# Access Compliance Report

## Public Rights-of-Way

Intersection ID: 3035	Main Street: BROWNE_RD	Cross Street: FAWNDALE_DR	Location: S
ADA ID: 963185F0D3AC	Ramp Type: Perp	Initial Pass/Fail: Fail	Overall Compliance: No
Severity Score: 12.5			
Codes/Mitigation Info/Possible Solution		Field Measurements/Component Compliance

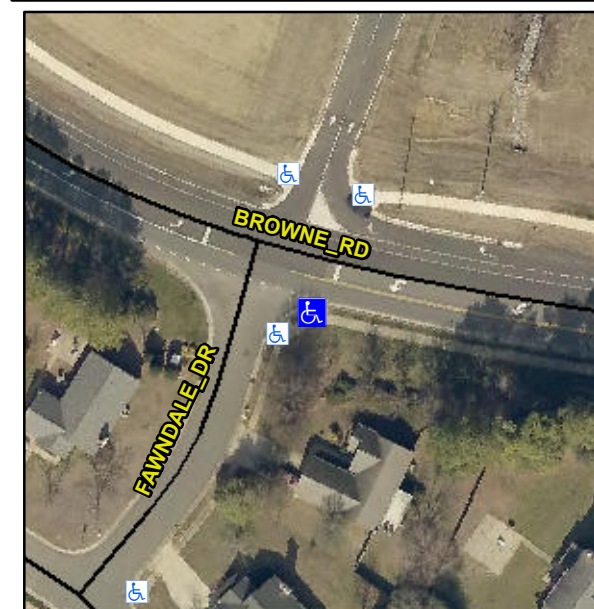
Compliance	Description	Data	Compliance	Description	Data
N/A	Ramp Length (in)	43.0	No	Ramp Slope (%)	11.8
Yes	Ramp Width (in)	48.0	Yes	Ramp XSlope (%)	2.0
N/A	Flare Type LT	N/A	N/A	Flare Type RT	N/A
N/A	Flare Slope LT (%)	N/A	N/A	Flare Slope RT (%)	N/A
N/A	Flare Traversable LT?	N/A	N/A	Flare Traversable RT?	N/A
N/A	Landing Length (in)	N/A	N/A	DWS Provided?	N/A
N/A	Landing Width (in)	N/A	N/A	DWS Contrast?	N/A
N/A	Landing Slope (%)	N/A	N/A	DWS Length (in)	N/A
N/A	Landing X Slope (%)	N/A	N/A	DWS Full Width?	N/A
N/A	Landing Curb? (Y/N)	N/A	N/A	DWS Offset (in)	N/A
N/A	Shared Landing?	N/A			
N/A	Gutter Ponding?	N/A	N/A	Gutter Slope (%)	N/A
N/A	Gutter Lip Ht (in)	N/A	N/A	Gutter X Slope (%)	N/A
N/A	Painted X Walk1?	No	N/A	Painted X Walk2?	N/A
	X Walk 1 Direction	To NE		X Walk 2 Direction	N/A
N/A	X Walk 1 Width (in)	N/A	N/A	X Walk 2 Width (in)	N/A
	X Walk 1 Slope (%)	1.8		X Walk 2 Slope (%)	N/A
	X Walk 1 X Slope (%)	1.4		X Walk 2 X Slope (%)	N/A

**Remove & Replace Entire Ramp.**
